UNITED STATES PATENT AND TRADEMARK OFFICE

APPLICATION NO.	FILING DATE	FIRST NAMED INVENTOR	ATTORNEY DOCKET NO.	CONFIRMATION NO.
10/763,292	01/23/2004	Yasunori Muramatsu	TIJ-35682	6492
23494	7590	04/06/2005	EXAMINER	
TEXAS INSTRUMENTS INCORPORATED P O BOX 655474, M/S 3999 DALLAS, TX 75265			VU, BAO Q	
			ART UNIT	PAPER NUMBER
			2838

Office Action Summary	Application No. 10/763,292	Applicant(s) MURAMATSU ET AL.	
	Examiner Bao Q. Vu	Art Unit 2838

DETAILED ACTION

FIG. 3A

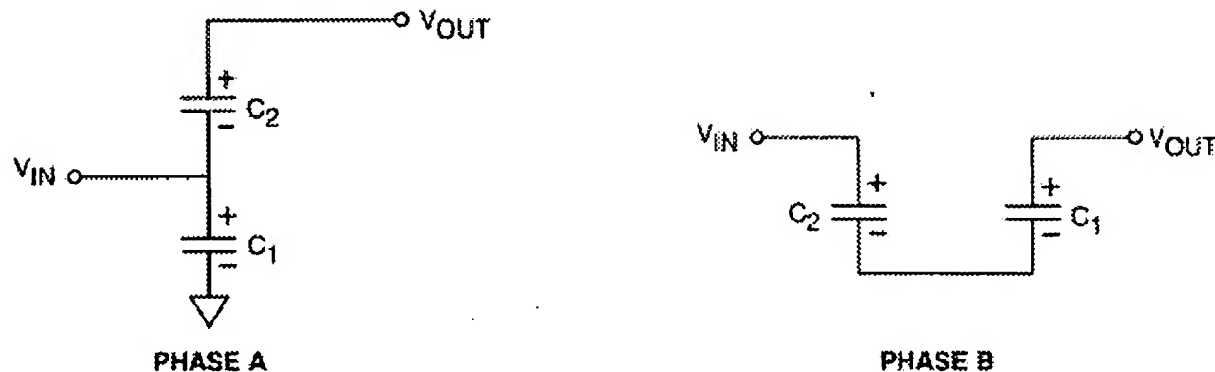
4. Claims 1-4, 18 and 19 are rejected under 35 U.S.C. 102(b) as being clearly anticipated by Rader et al. (USP 6,504,422). Rader discloses the claimed connection of applicant's claims see below 3A. The exact same figures as applicant's figure 1a and 1b. For claim 18, the current control circuit see figure 6.
